SUTTON CONSERVATION COMMISSION

June 25, 2014

MINUTES

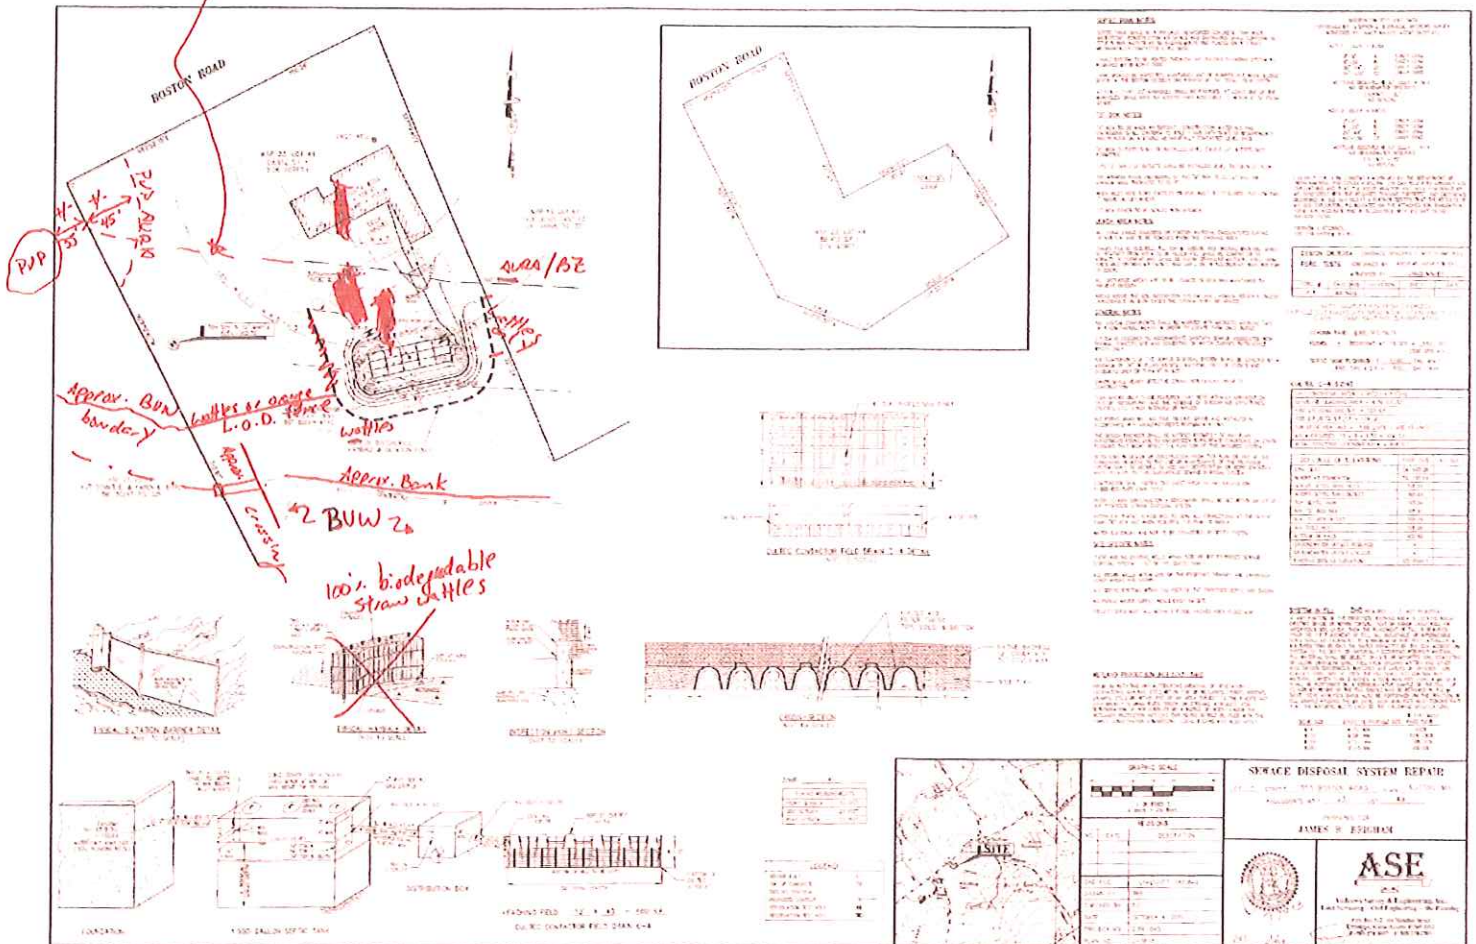
I have red-lined the plan commensurate with the comments above.

Extend AURA/BZ
assoc. w/ BUW

* Make sure L.O.D. gets extended to property lines so there
are no open ends.
